ECN/PCN No.: 4327

For Manufacturer			
Product Description: Oven Controlled Crystal Oscillator	Abracon Part Number / Part Series: AOCJY	☐ Documentation only ☒ ECN ☐ EOL	☒ Series ☐ Part Number
Affected Revision: H	New Revision: I	Application:	☐ Safety ☒ Non-Safety

Part Number Builder:

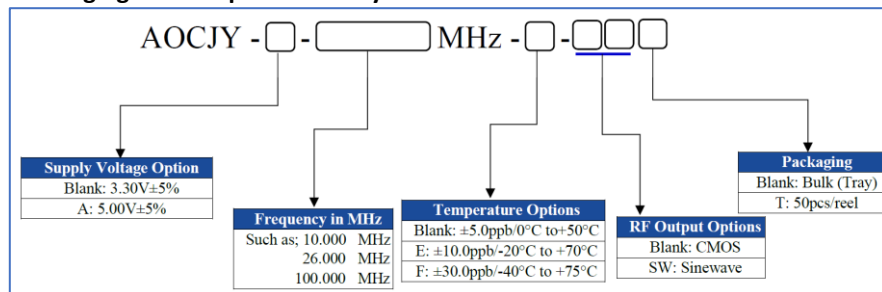
-Packaging for Bulk product= Tray

Part Number Builder:

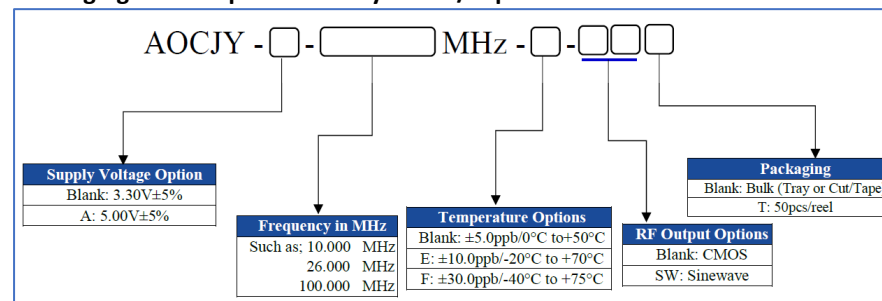
-Packaging for Bulk product= Tray or Cut/Tape

Standard product series review and upgrade. Updated packing method for higher volume quantities.
